Interactive comment on “An innovative treatment concept for future drinking water production: fluidized ion exchange-ultrafiltration-nanofiltration-granular activated carbon filtration” by S. Li et al.

S. Li et al.

Received and published: 18 March 2009

Fig. 1. Rejection of micro pollutants after 3-day filtration and 4-day filtration.

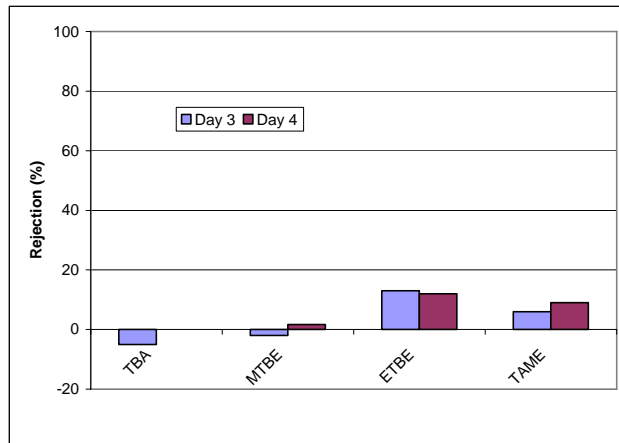
3. **Q:** The explanation of higher MTBE and TBA in NF permeate than NF feed is not reasonable.

A: Yes, we agree with the referee. The explanation of higher MTBE and TBA in NF permeate than in NF feed is not reasonable. After checking the raw data (Figure 1 in this file), the higher MTBE and TBA in NF permeate is due to the discrepancy of measurements and only one measurement listed in table. In the Table 3 of the manuscript, only the data of the left column in the following figure is listed. And we cannot explain exactly why there is a difference between two measurements.
